Memorandum No: 23-114

Re: New River Crossing – Mooney Consulting Final Report

Michael Mooney Consulting, LLC
Golden, Colorado 80403

Re: New River Crossing study

Fig. 1. Proposed 42 ft bored diameter, 38 ft inside diameter tunnel in 2020 Corradino Group feasibility report. Cross-section shown at the New River crossing.

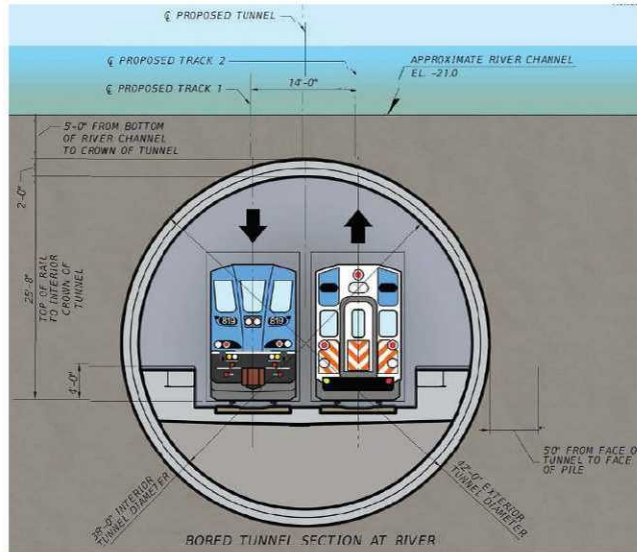
A 42 ft excavated (bored) diameter, 38 ft finished (inside) diameter tunnel was proposed in the 2020 Corradino group feasibility report (Fig. 1). The vertical alignment shows this single tunnel as passing 5 ft beneath the New River crossing (Fig. 1). Twin 25 ft excavated diameter, 23 ft inside diameter tunnels were proposed in the 2022 PD&E presentation. The vertical alignment show these twin tunnels as

passing 25 ft beneath the New River crossing (Fig. 2). The tunnel lining would be on the order of 18 in. thick for the single tunnel and 12 in. thick for the twin tunnels. The twin tunnels option requires nine cross passages to provide emergency egress. Cross passages are constructed by manual excavation (termed the sequential excavation method, SEM) that is time consuming and introduce risk of surface deformation (settlement) and building/utilities damage.

It is also worth noting that the Port of Miami TBM excavated less than one diameter below the ship channel. The depth of tunnel under the New River crossing is important as it dictates the length of the tunnel and portal to the south. The shallower the tunnel, the less length of tunnel/portal to the south. The 2020 report shows the 42 ft outside diameter TBM tunnel just 5 ft below the river (Fig. 1) while the 2022 report shows the 25 ft outside diameter twin tunnels as 25 ft below the river (Fig. 2). Tunneling with 5 ft of cover is on the extreme end, would require ground improvement of the river channel via

grouting, and would create buoyancy concerns for the tunnel, i.e., air-filled tunnel wanting to rise. That said, the New River crossing is a very short span and therefore, construction beneath it could be tightly controlled. It is likely that this cover depth would need to be increased from 5 ft, and further detailed analysis is required to determine what depth. I do feel that 25 ft cover depth is conservative for either the 25 ft TBM tunnel or the 42 ft TBM tunnel, and that a reasonable solution can likely be developed for a cover depth in the 10 ft range.

Fig. 1. Proposed 25 ft bored diameter, 23 ft inside diameter tunnel in 2022 PD&E public workshop presentation. Cross section shown at the New River crossing.

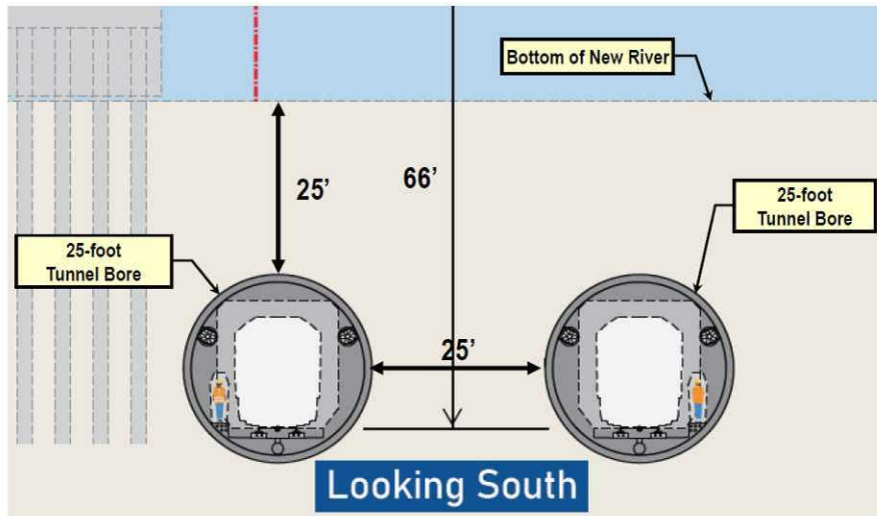
The twin 25 ft excavated diameter tunnel arrangement proposed in the 2022 report is based on decades of precedence with similar arrangements. The twin tunnel arrangement does require cross passage construction for emergency egress via the sequential excavation method (SEM) that is essentially a hand mining approach. The 2022 report estimated that 9 cross passages are required. The sand between the two tunnels will need to be frozen or grouted to enable stable cross passage construction. A similar approach to this was performed during construction of the twin Port of Miami tunnels. The process of cross passage construction can be challenging and time consuming, and this effort cannot generally take place until after the main tunnels have been completed. Therefore, the

cross passage construction during twin tunnel approach lengthens the project, e.g., can be on the order of 3 additional months per cross passage).

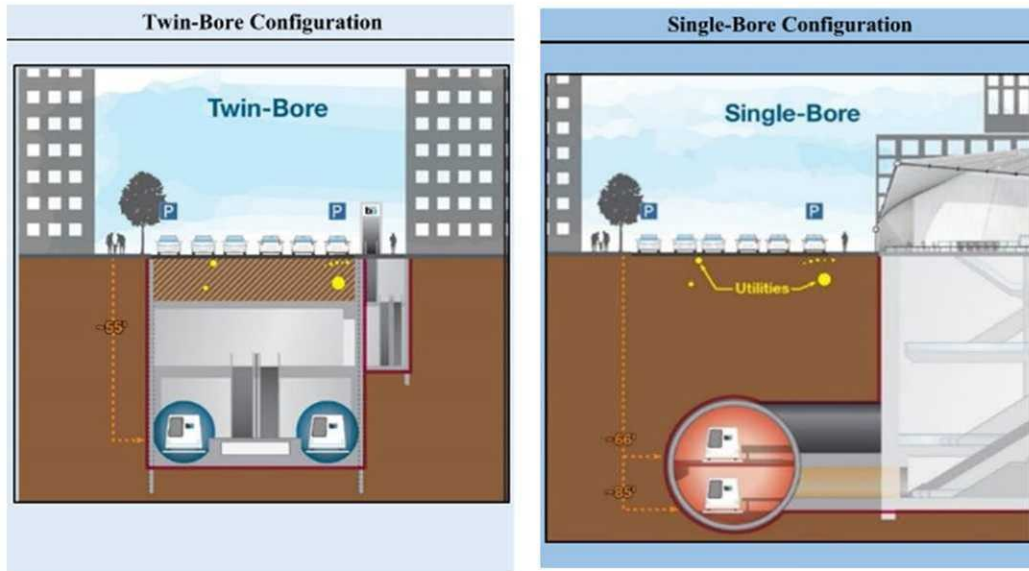
A 1200 ft long by 72 ft wide by 90 ft deep cut and cover excavation is proposed for the station in the 2022 presentation report. This essentially involves a large box excavation the length of four football fields in downtown Fort Lauderdale that would be extremely disruptive. This approach also brings into play significant interaction with existing utilities that introduces considerable cost risk.

A more recent trend in transit construction is to create smaller surface footprint stations off to the side of the tunnel, and as described above, use the larger single bore to house the station platforms. See Fig. 4 for an example comparison. This greatly reduces surface disruption and utility risk.

Fig. 5. Example station configurations (Toronto Scarborough Line top three, BART to San Jose Line bottom) for larger single bore tunnels where surface access and disruption is minimized.

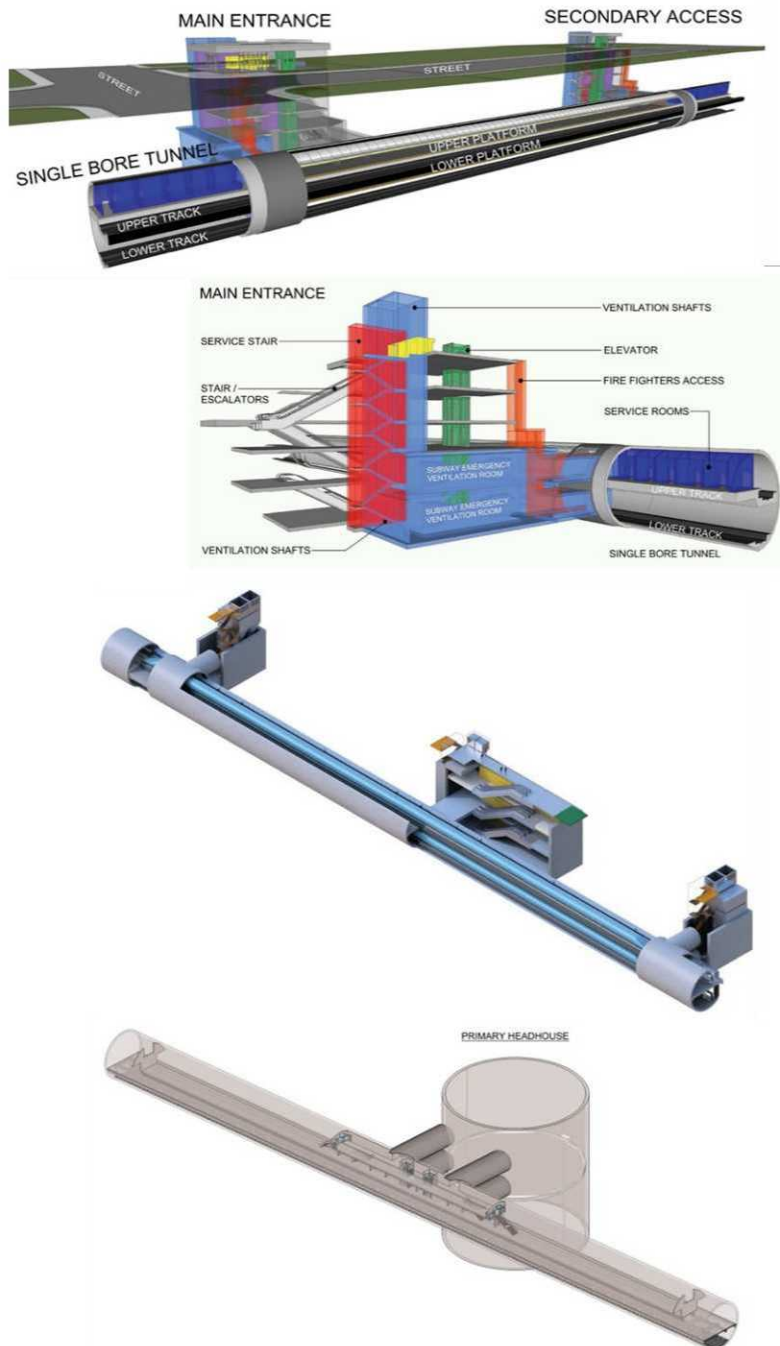
Figure 5 shows rendered designs for the Toronto Scarborough line and the BART to San Jose line where the station platforms are constructed within the single bore tunnel and the surface access to the trains is minimal. This is a significantly different and less disruptive approach than the 1000 ft long cut and cover station proposed in the FDOT studies.

In the projects stated above, the station design, e.g., platform size, typically defines the diameter of the overall tunnel. Careful assessment of this is required but this would likely be larger than the 38 ft ID proposed in the 2020 report. The 35 ft wide platform and 67 ft overall ID width conveyed in the 2022 report extends beyond bored tunnel capability; however, this width can be reduced considerably through optimization like has been done in San Jose, Toronto, Barcelona, etc. Alternatively, the station

could be expanded from the existing single bore tunnel using SEM construction techniques, all done from within the bored tunnel without surface and utility disruption.
